26 November 2018

Our ref: 2316484  
Your ref:

**Enirgi Power Storage Recycling (EPSR) Consolidation Project EIS (SSD 6619),  
Response to Submissions Report  
Additional response to DP&E enquiries**

12(i). Annotations on relevant plans to show the process flow

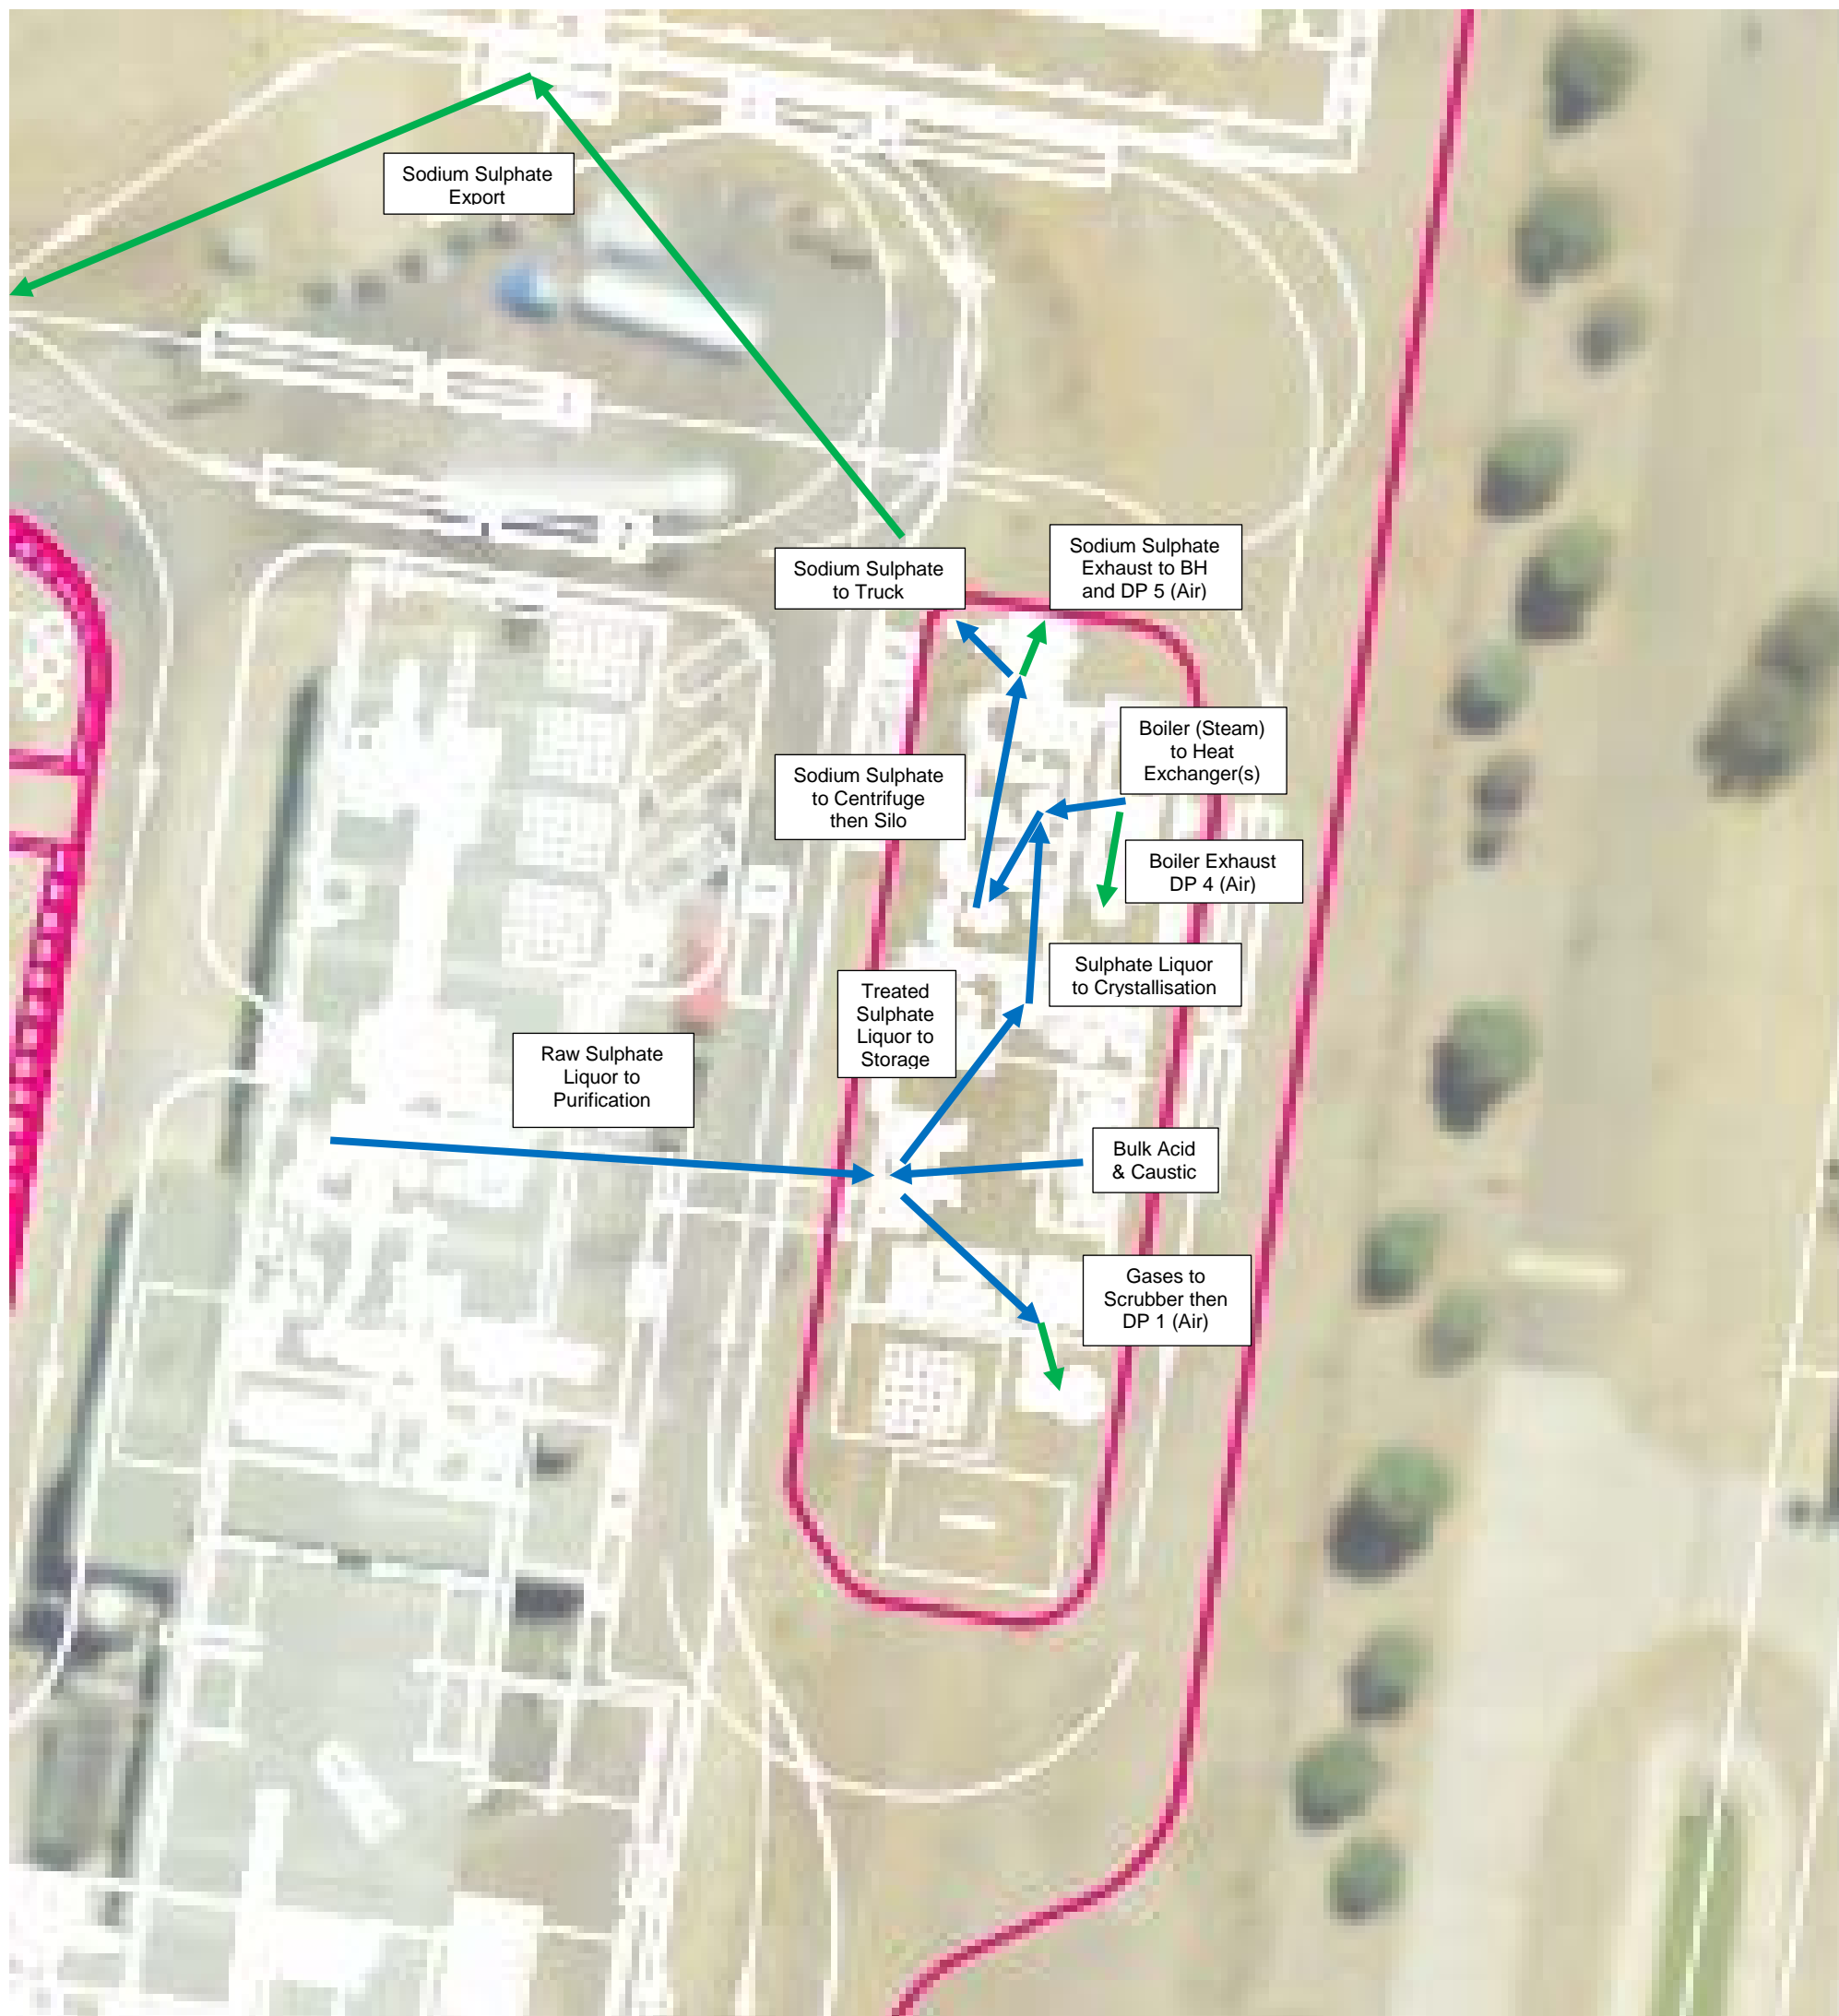
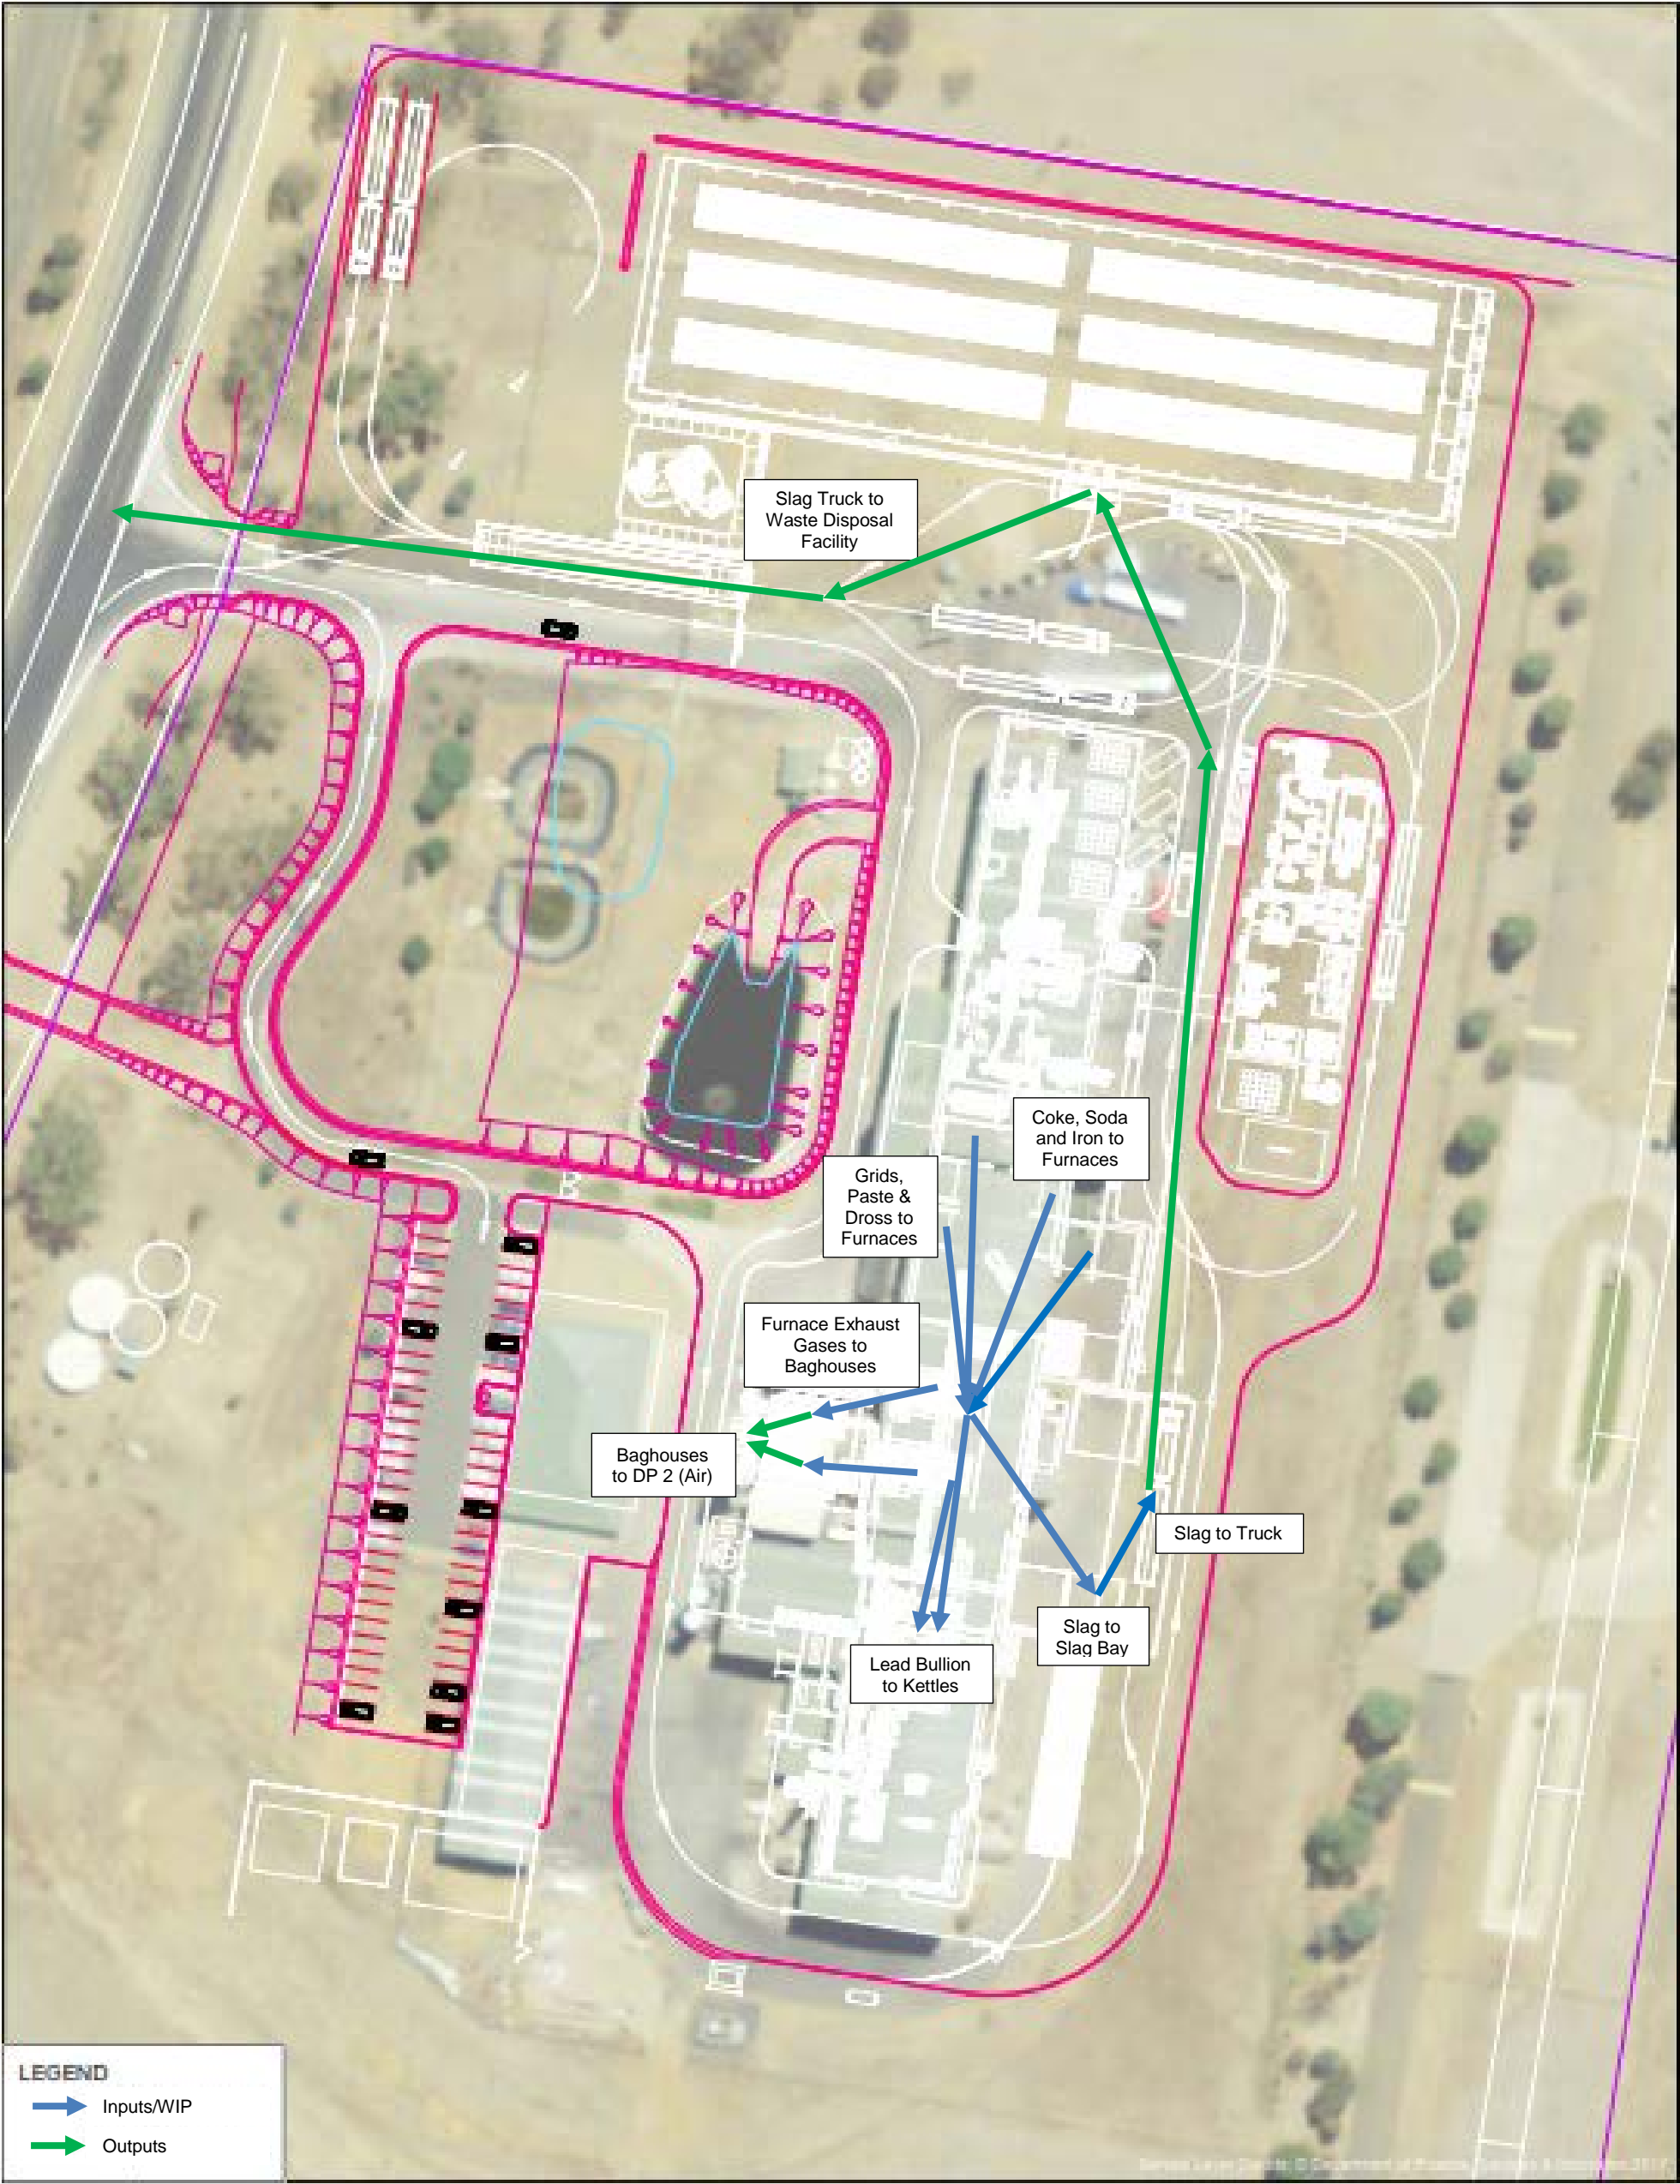
- **updated annotated plans including a plan of the existing site. Please ensure that the plan of the development includes all components of the proposal (including the informal car park, administration building and stormwater detention basin) and that all plans are legible when zoomed in**

Please annotate and include the plastics facility on the general site plan of the proposed development

Provide detailed plans of the plastics facility

- **plans of the new internal roads**  
Provide plans of the new internal roads
- **an annotated engineering drawing of the plastics recycling facility including all components**  
Please provide
- **annotations on relevant plans to show the process flow.**  
Please provide the plan as requested above.

Figure 4-3 in the EIS clearly shows an annotated plan of the PRRF, and Figure 3-4 of the Response to Submissions is an annotated drawing of the key features and proposed new infrastructure of the ULAB facility. This information was presented in two separate figures to allow sufficient detail and visibility.

A new figure showing the information on one single site plan figure has now also been provided as Attachment 2.

Ground Floor Plans of the PRRF have been provided in Appendix D of the EIS. These plans are the same plans that formed part of the Development Consent (DA16/0386) for the PRRF and are all that are currently available. There are no changes proposed to the PRRF, however annotated engineering drawings are now being prepared and will be forwarded within the next week.

As mentioned in section 3.1.2 of the Response to Submissions, concept level design of the new internal roads has been provided in Appendix C of the Response to Submissions Report. This is considered sufficient detail to define the potential environmental impacts associated with the development and is commensurate with the requirements of the Environmental Planning and Assessment Regulation 2000, and typical of the level of detail that is provided in other SSD applications.
